# SERVICE BULLETIN

Ride: TRABANT

Subject: REPLACEMENT OF FLOOR CLEVIS  
FOR LIFT CYLINDERS

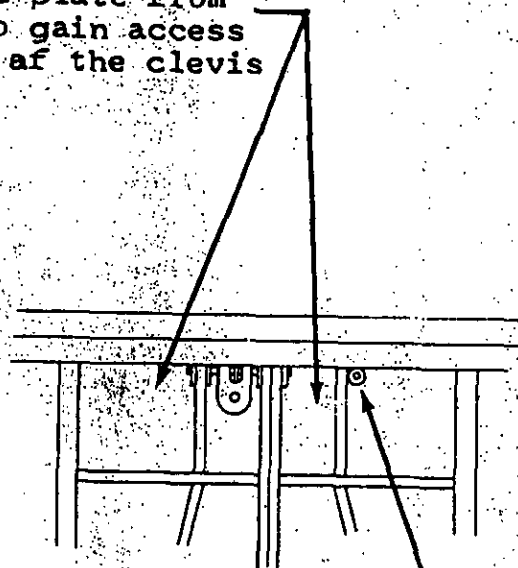
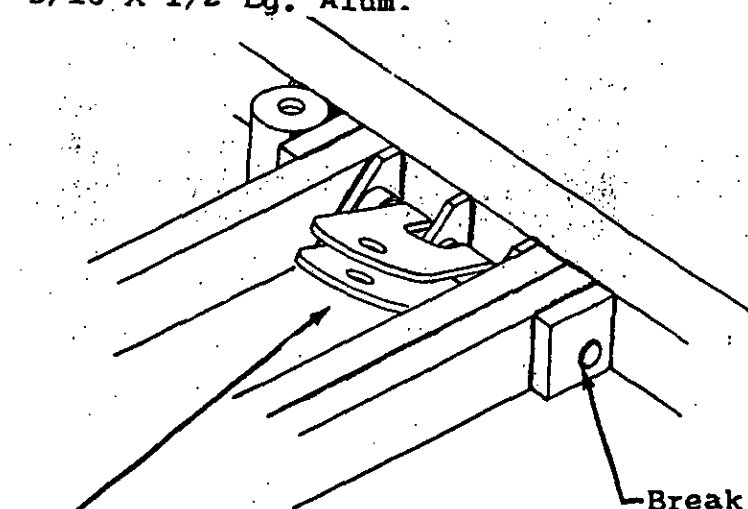
During recent inspections of rides returning to the factory, a condition was brought to our attention that is unsafe. The clevises attached to the floors for the lift cylinders are fatiguing where they are bent around the pin. This condition is probably a result of improper heat treating which has caused the metal to crystalize or become brittle in the bent area.

In order to obtain enough clearance for the new clevis, it may be necessary to bend the plate which is welded to the support tubes. To accomplish this, heat the plate with an acetylene torch and strike it several blows with a hammer.

Relocate socket as shown in drawing.

Remove tread plate from this area to gain access to the ends of the clevis pin

Heat plate and bend if necessary to gain clearance for new clevis

Break welds loose on both ends of pin

Relocate Floor Stand Support Socket to this location.

Knock the pin loose and install new pin and clevis, securing pin with 1/8 x 1" long cotter pin on both ends.

NEW CLEVIS P/N 1030200-42

NEW PIN P/N 1030200-43

### Addition of Check Valve

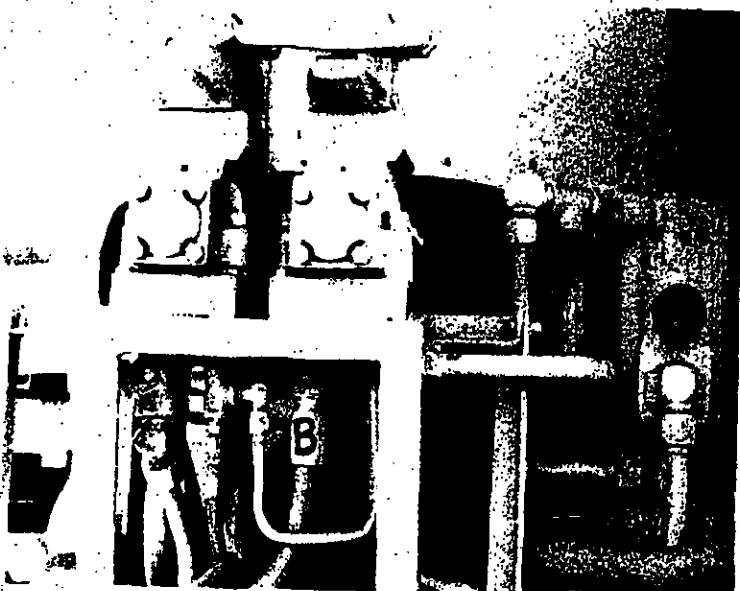
PLUG ADDITIONAL SIDE PORT  
IN EXISTING TEE AFTER  
REMOVING ELBOW & HOSE

CONNECT NEW HOSE FROM  
THE TEE "Y PORT" TO  
EXISTING EXTRA TANK PORT

ADD NEW CHECK  
VALVE, BUSHINGS &  
CLOSE NIPPLE BETWEEN  
HOSE & ST. ELBOW

To stop Barrel Creeping, a Check Valve can be added in the return line from the motor. This will equalize pressure on both sides of the motor.

Screw the Check Valve with nipple and bushings into the St. Elbow on the bottom side of the Relief Valve.

Be sure Check is installed with Arrow pointing away from Relief Valve.

Re-connect Hose from Check Valve to B Port of the Directional Control Valve.

Figure 1

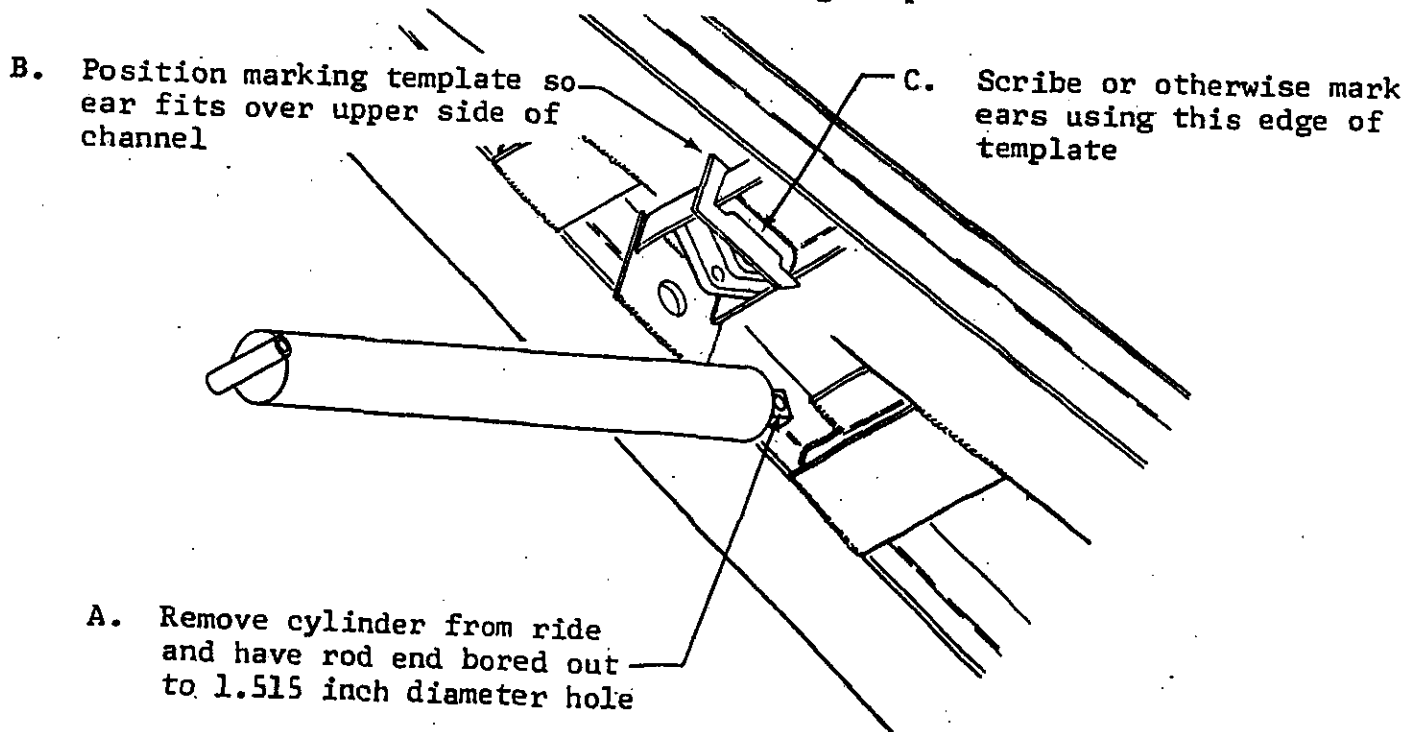
Position cutting template so the small ear fits over the upper side of the channel.

Scribe or use a magic marker or soap stone, etc., to mark a line along each ear following the inside edge of the cutting template.

Figure 2

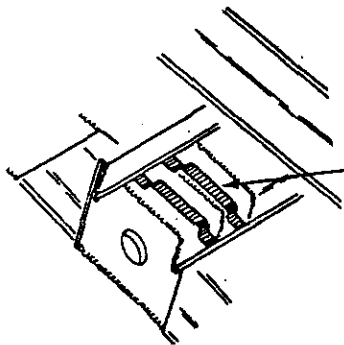
5. With a cutting torch, cut off each ear as close as possible to the line that you have marked on them.

Torch old ears off along line, should look approximately like this when complete

Figure 3

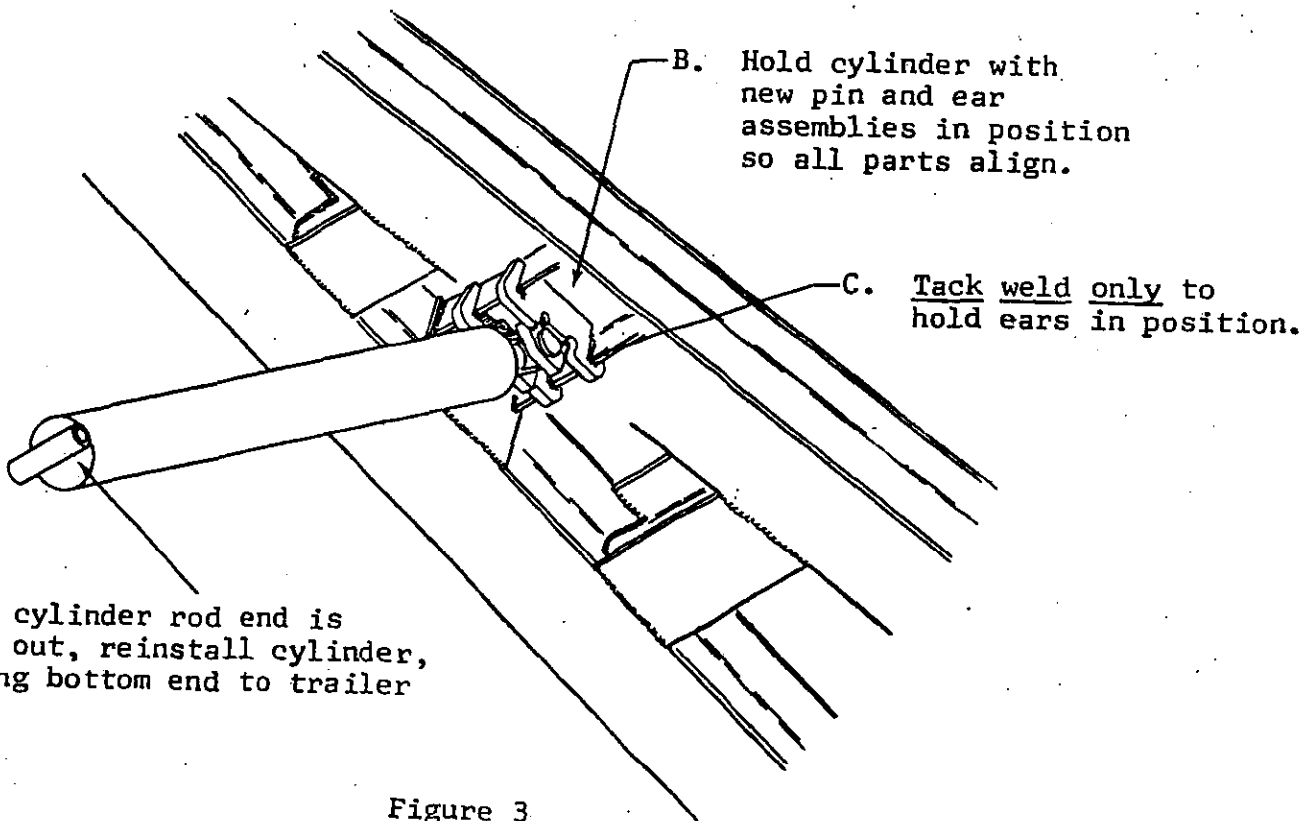
6. Place each new ear assembly up against the old ear and channel to see that each one fits flat against the inside of the channel and flat against remaining portion of old ear.

If new ear assemblies do not fit, torch or grind a small amount off the old ears.

7. Pin bottom end of lift cylinder.
8. Insert new pin through cylinder rod end and new ears.
9. Hold or block cylinder so new ears are in proper position and tack weld ears in place.

A. After cylinder rod end is bored out, reinstall cylinder, pinning bottom end to trailer

Figure 4

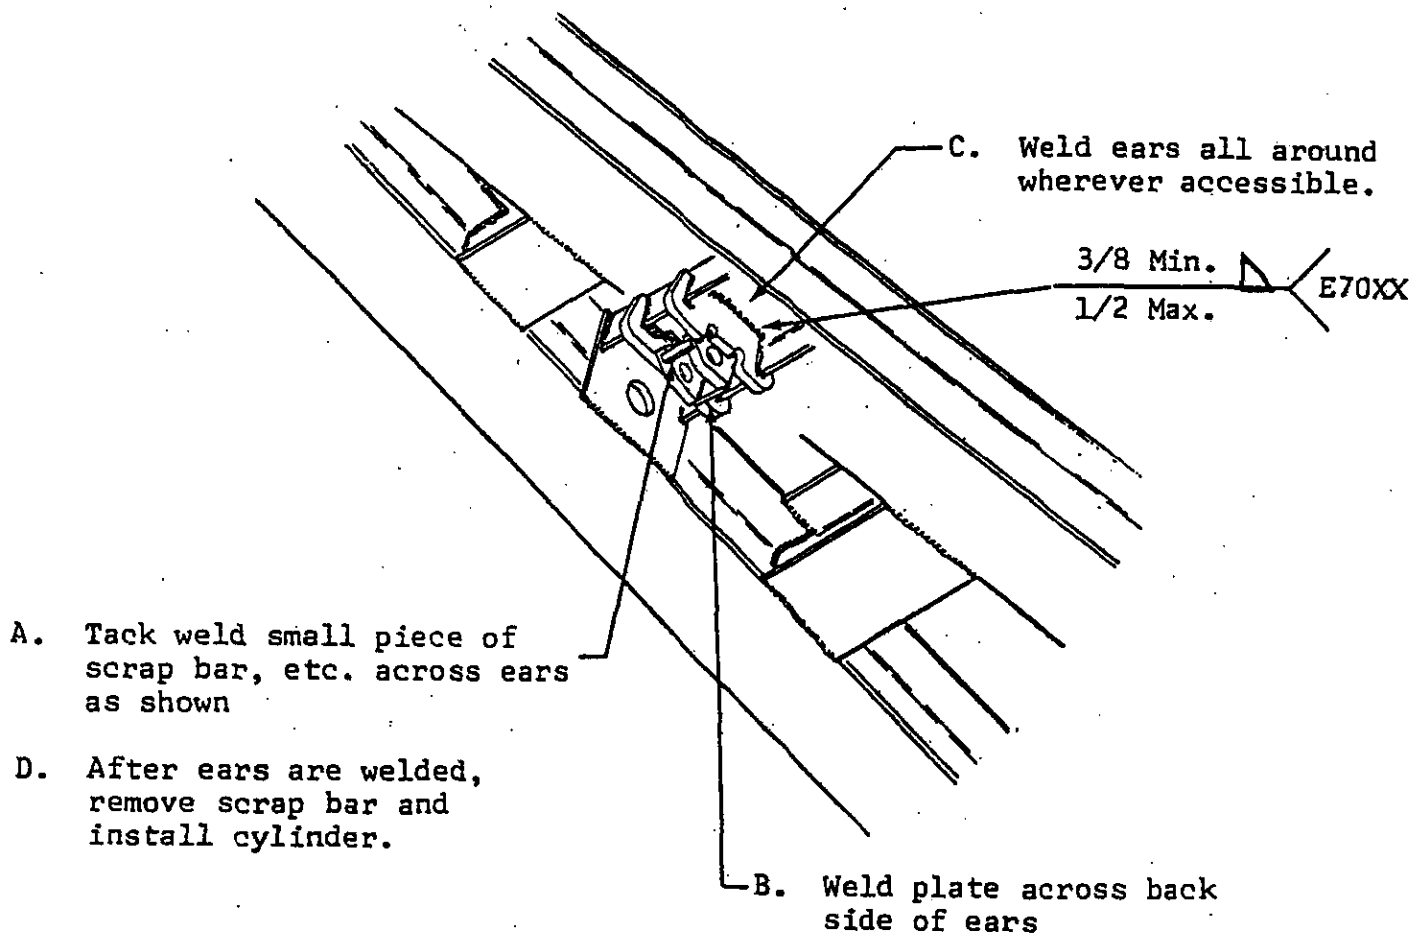
10. Remove pin and let cylinder drop down so it is not in the way.
11. Weld ear assemblies in place as shown in Figure 4.
12. Secure cylinder with new pin and cotter pin.

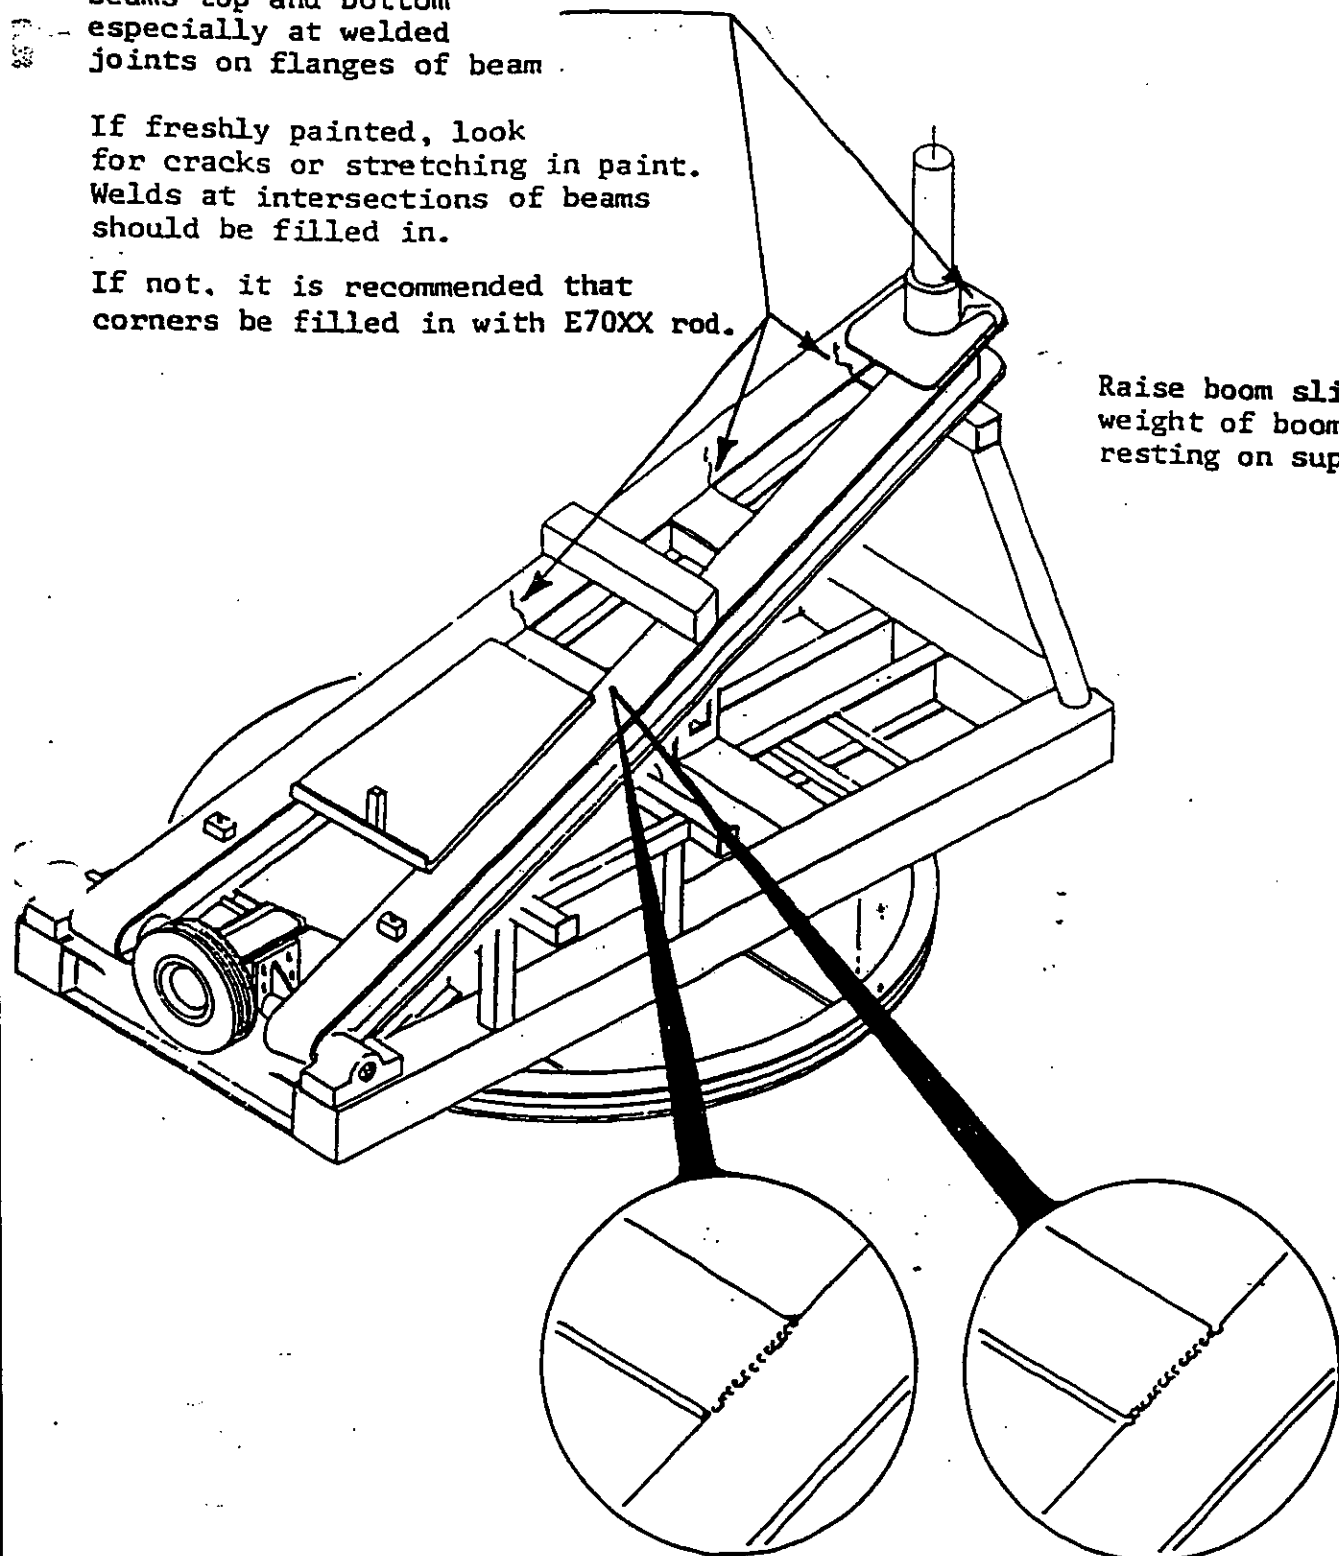
Inspect for cracks along beams top and bottom especially at welded joints on flanges of beam.

If freshly painted, look for cracks or stretching in paint. Welds at intersections of beams should be filled in.

If not, it is recommended that corners be filled in with E70XX rod.

Raise boom slightly so weight of boom is not resting on support.

Desired weld joint

Undesirable weld joint
